Work Order ID 125270

DESIGN #	DRAWN BY CP	DART AEROSPACE LTD HAWKESBURY, ONTARIO, CANADA	
CHECKED #	APPROVED #	DRAWING NO. D3166	REV. A SHEET 1 OF 1
DATE 02.07.10		TITLE BASKET HOOP	SCALE NTS
A	02.07.10	NEW ISSUE	
A1	04.04.08	38+/- WAS 36.0

DRAWING NO. D3166	TITLE BASKET HOOP	REV.A1	DART AEROSPACE LTD ENGINEERING ORDER		D.E.O. NO. D3166-A-2	SHEET NO. 1 OF 1	SCALE NTS
DRAWN AJS	CHECKED J	MFG. APPR. M	APPROVED MD		DE APPR. H		
DATE 08.12.11	DATE 08.12.15	DATE 08/12/15	DATE 08/12/16		DATE 08.12.16

D3166-1 BASKET HOOP

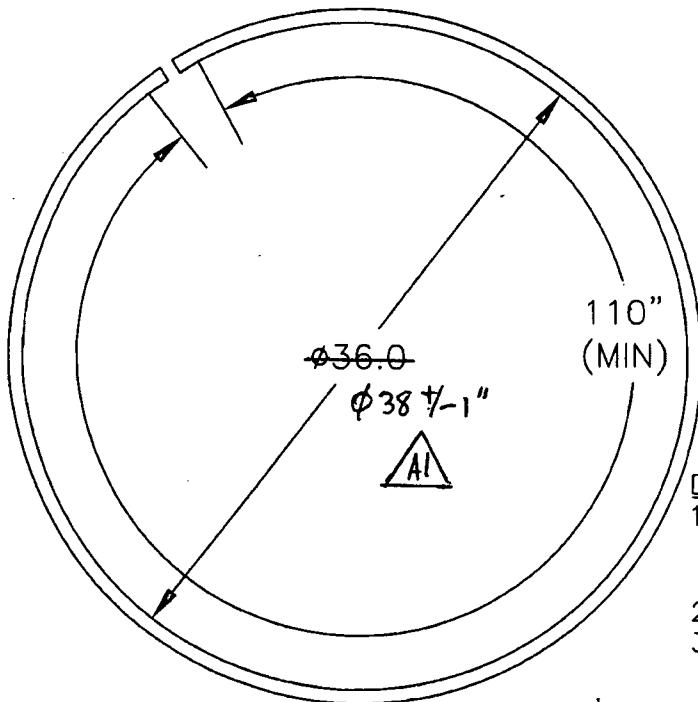
1) MODIFY MATERIAL NOTE FOR D3166-1 AS SHOWN:

IS:

- 1) MATERIAL: AISI 304/316 SS, 3/4 X 3/4 X 0.065 WALL SQUARE TUBING,
60.00" LONG
REF. DART SPEC M304TS0.750W.065

WAS:

- 1) MATERIAL: AISI 304/316 SS SQUARE TUBING,
0.75" x 0.75" x 0.063 WALL, 60.00" LONG
(REF DART SPEC. M304TS0.750W.063)

2) MODIFY MATERIAL NOTE FOR D3166-3 AS SHOWN:

IS:

- 1) MATERIAL: AISI 304/316 SS, 3/4 X 3/4 X 0.065 WALL SQUARE TUBING,
120.00" LONG
REF. DART SPEC M304TS0.750W.065

WAS:

- 1) MATERIAL: AISI 304/316 SS SQUARE TUBING,
0.75" x 0.75" x 0.063 WALL, 120.00" LONG
(REF DART SPEC. M304TS0.750W.063)
